MATRIX	Service Bulletin 0140 Error Code	
Effective Date: Feb 6, 2017	Models Affected: T1X-04-C (TM706) T3X-05-C (TM707), T1XE/3XE/3XH (TM708), XR (TM697)	Bulletin Number
Prepared by: Alex Tang		NB-1705003

PROBLEM

The console displays 0140 error on the screen.

Fig-3

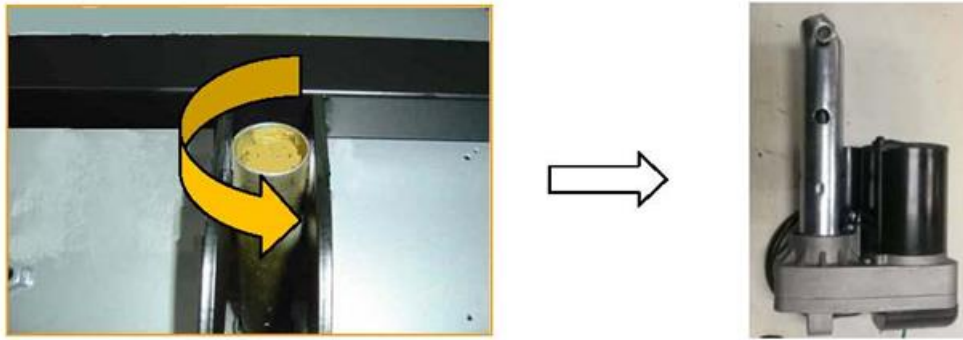
6. Turn the threaded rod counter-clockwise 1 ½ to 2 turns (Fig-3 and Fig-4).
